Access Compliance Report

Public Rights-of-Way

Intersection ID: 28215	Main Street: ARDREY_KELL_RD	Cross Street: LANDING_GREEN_DR	Location:	N
ADA ID: 8BF9583F733A	Ramp Type: PerpDiag	Initial Pass/Fail: Fail	Overall Compliance: No	Severity Score: 26.25

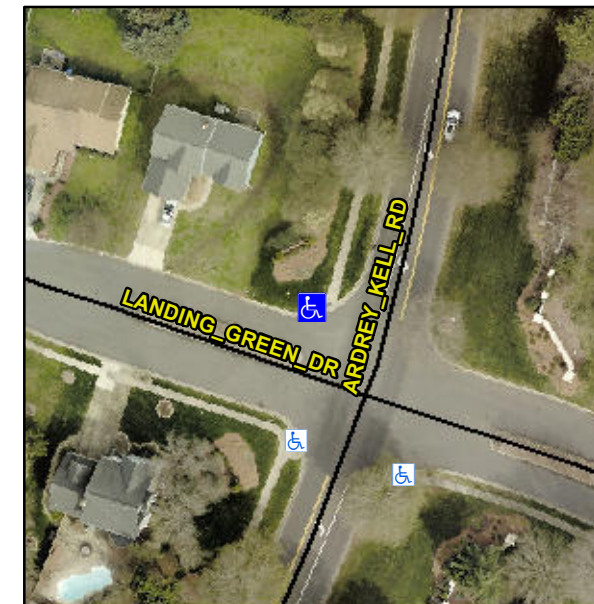
Not Found, R304.2.2, R304.5.3

Compliance	Description	Data	Compliance	Description	Data
N/A	Ramp Length (in)	37.5	No	Ramp Slope (%)	13.0
Yes	Ramp Width (in)	57.5	No	Ramp XSlope (%)	3.5
N/A	Flare Type LT	N/A	N/A	Flare Type RT	N/A
N/A	Flare Slope LT (%)	N/A	N/A	Flare Slope RT (%)	N/A
N/A	Flare Traversable LT?	N/A	N/A	Flare Traversable RT?	N/A
N/A	Landing Length (in)	N/A	N/A	DWS Provided?	N/A
N/A	Landing Width (in)	N/A	N/A	DWS Contrast?	N/A
N/A	Landing Slope (%)	N/A	N/A	DWS Length (in)	N/A
N/A	Landing X Slope (%)	N/A	N/A	DWS Full Width?	N/A
N/A	Landing Curb? (Y/N)	N/A	N/A	DWS Offset (in)	N/A
N/A	Shared Landing?	N/A			
N/A	Gutter Ponding?	N/A	N/A	Gutter Slope (%)	N/A
N/A	Gutter Lip Ht (in)	N/A	N/A	Gutter X Slope (%)	N/A
N/A	Painted X Walk1?	No	N/A	Painted X Walk2?	No
	X Walk 1 Direction	To SW		X Walk 2 Direction	To SE
N/A	X Walk 1 Width (in)	N/A	N/A	X Walk 2 Width (in)	N/A
	X Walk 1 Slope (%)	1.5		X Walk 2 Slope (%)	1.6
	X Walk 1 X Slope (%)	2.1		X Walk 2 X Slope (%)	1.5

Remove & Replace Curb Ramp With Two New Directional Ramps or Equivalent.
